EXPLANATION OF SIGNIFICANT DIFFERENCE

LAKESIDE VILLAGE APARTMENTS SITE

Lancaster / Erie County / Site No. C915344 / September 2025

Prepared by the New York State Department of Environmental Conservation
Division of Environmental Remediation

FIGURE:
ESD Figure 3

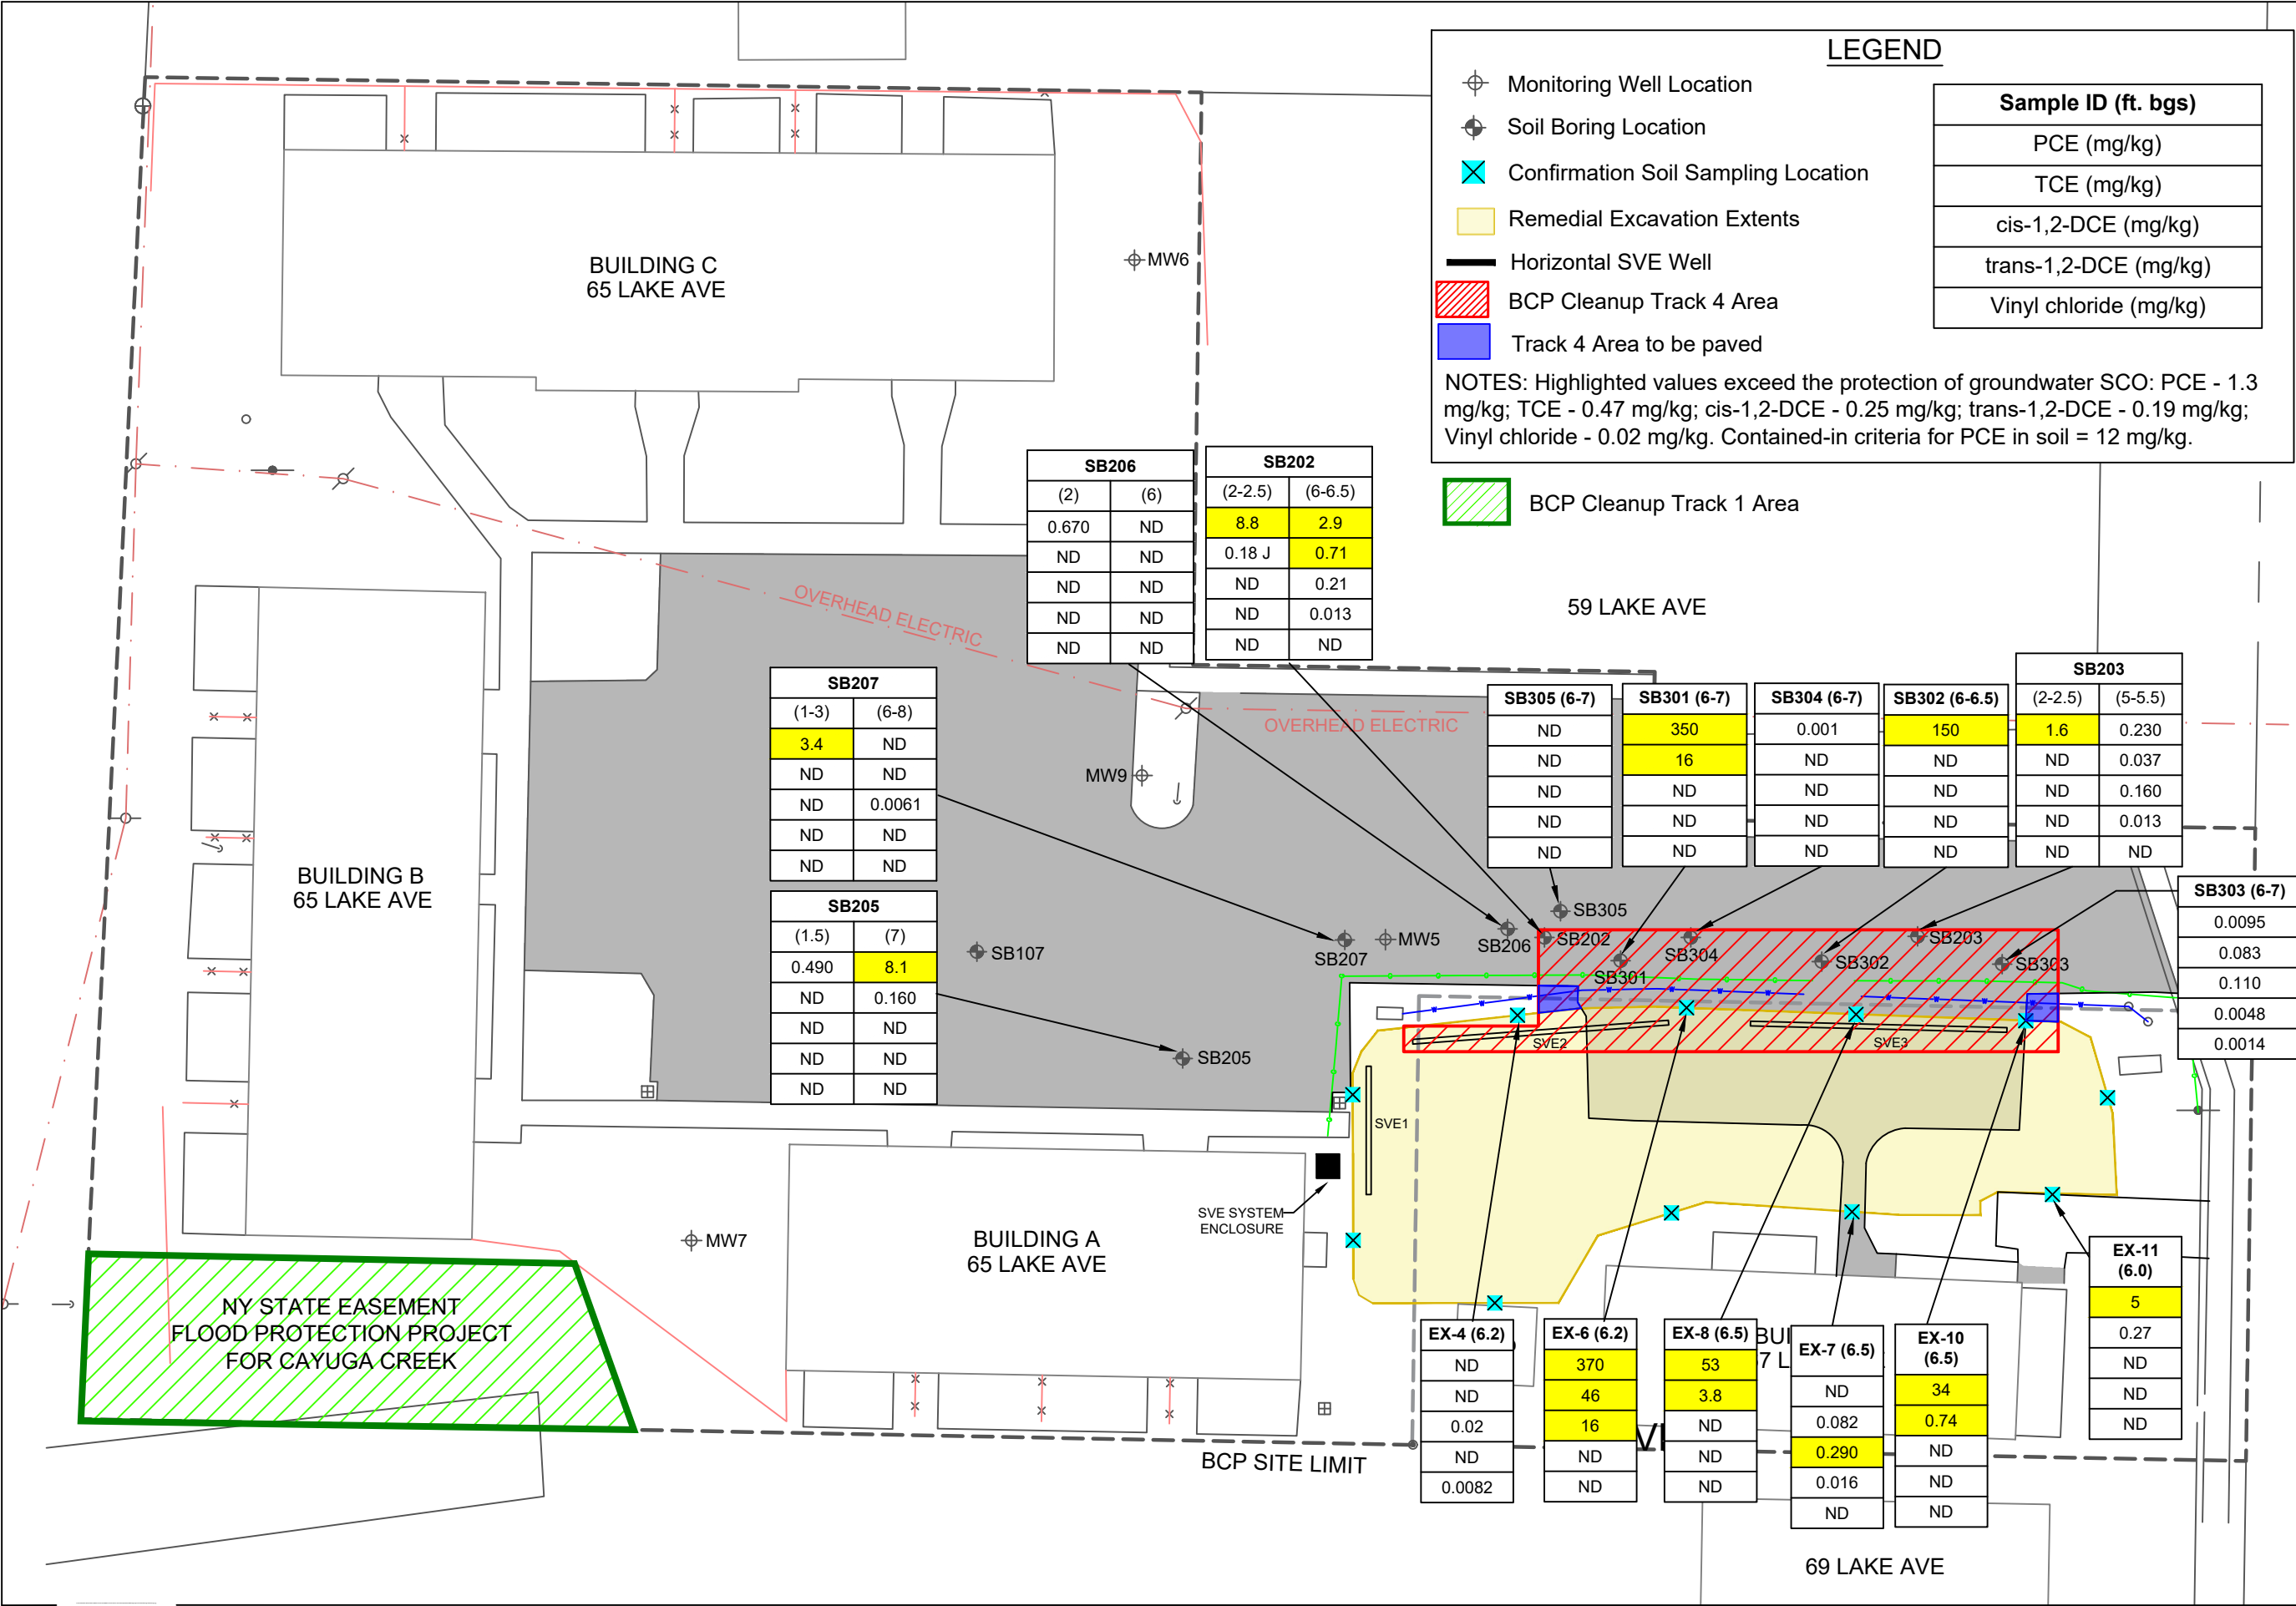
The locations of the underground gas and water utilities in front of Building A and through the center of the parking lot present a significant logistical challenge to soil excavation. The sanitary sewer is also assumed to be located within this utility corridor. The more permeable backfill surrounding the utilities may serve as a preferential pathway for vapors into Buildings 1 and A. To that end, contamination in the backfill and soils in the vicinity of the utility corridor was addressed with the SVE system as discussed in the 2023 RAWP (see Figure 3).

As the remaining PGWSCO exceedance do not satisfy the Track 2 remedy requirements for soil and the applicant has proposed to change to a Track 4 remedy for the area where soils exceeding PGWSCOs remain proximate to the utility lines. The horizontal SVE wells (SVE2 and SVE3) that were previously installed as part of the Remedial Action Work Plan can be used to treat the soil and a site cover will be constructed over the entire Track 4 area, which will consist of existing hardscape, portions of an expanded asphalt parking lot, and soil cover.

The Track 4 Remedy area includes the horizontal soil vapor extraction wells SVE2 and SVE3 that were installed to treat remaining soil contamination in the utility corridor. Based on results of the individual leg sampling completed in January 2025, contaminant concentrations in SVE1, located furthest from the impacted utility corridor, are approximately 35% of those in SVE2 and 16% of those in SVE3. It is anticipated that decommissioning SVE1 will result in an increase in the overall rate of contaminant removal from the impacted soil by the remaining SVE wells. SVE1 will be decommissioned by closing the valve at the manifold near the blower and the handle subsequently removed. Consequently, the Track 4 Remedy area does not include SVE1.

Most of the Track 4 area is newly paved and meets the Track 4 cover requirements for restricted-residential use as described in 6 NYCRR Part 375-3.8(e)(4)(iii) including two small areas of soil cover along the east and west boundaries measuring approximately 24 and 23 square feet each. Existing soil in these areas were sampled for VOCs by advancing a manual auger to a completion depth of 16 inches below grade. Results of the soils sampled concluded that VOC concentrations were lower than the restricted-residential SCOs and/or PGWSCOs for those contaminants found in site groundwater. Details of the cover installation will be included in the Final Engineering Report (FER).
